Central Valley Regional Water Quality Control Board
13/14 August 2020 Board Meeting

Response to Comments
for the
City of Sacramento
Combined Wastewater Collection and Treatment System
Tentative Waste Discharge Requirements

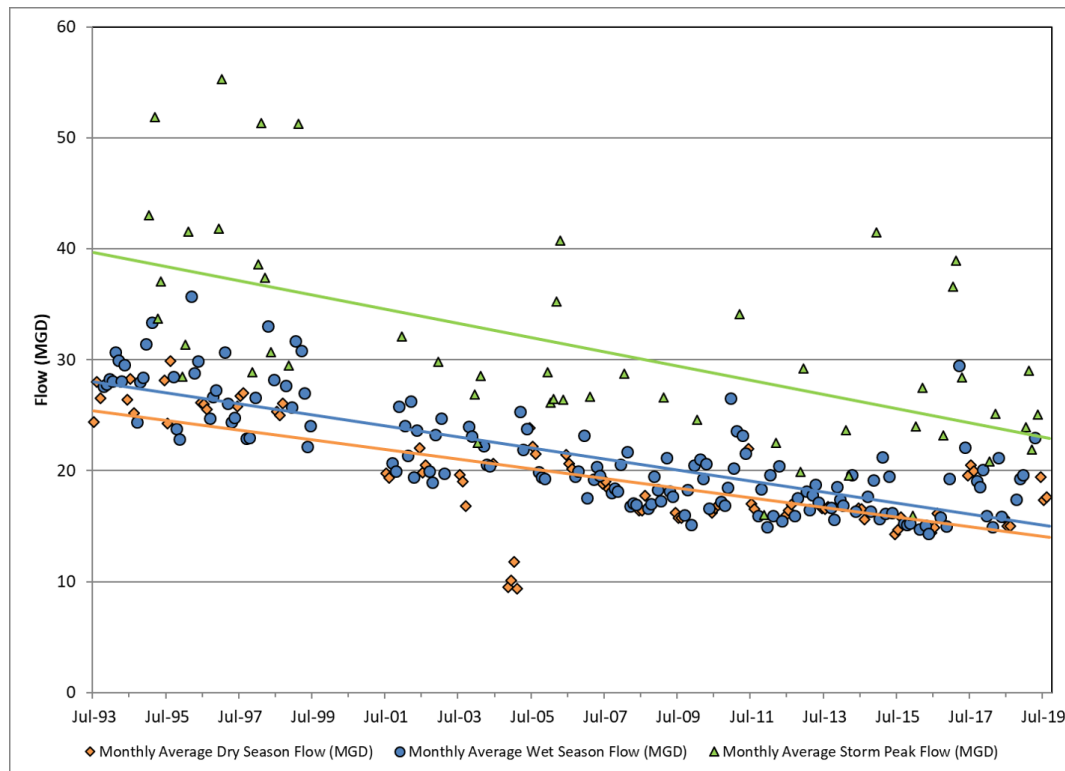
3. New planned urban growth, such as the Railyards, and lack of green infrastructure is increasing flows to the CSS at a rapid rate and will result in more overflows and outflows.

Finally, the Discharger's water conservation efforts have resulted in consistent and significant reductions in dry weather and dry season flows over the last 20 years. These flow reduction measures offset new flows to the CSS. The figure below shows the consistent downward trend and demonstrates that the CSS service area is not generating new flows. The overall annual average CSO discharge volume decreased by over 42 percent over the past 26 years. Water conservation, new plumbing codes for redevelopment, and ongoing collection system improvements are all factors in the gradual decrease in dry and wet weather flows over time.

The current and proposed permit also requires the City implements its Combined Wastewater Control System Plan of Operations to maximize its CSS flows are routed to the Sacramento Regional WWTP for treatment. During the current permit term (past 5-years) the City routed 95% of all CSS flows to the Sacramento Regional WWTP. As flows to the CSS increase due to new development and redevelopment the City must continue to maximize

Although the City has measures in place to address growth and flows have been decreasing over time, as discussed above, the tentative permit has been modified to add a new provision to manage flows due to growth to ensure CSOs and CSS outflows do not increase and the overall percentage of flow routed to the Sacramento Regional Wastewater Treatment Plant does not decrease due to growth within the CSS service area. The Special Provision regarding implementation of the LTCP (WDR section VI.C.4.c) has been updated to include the following subsection iii:
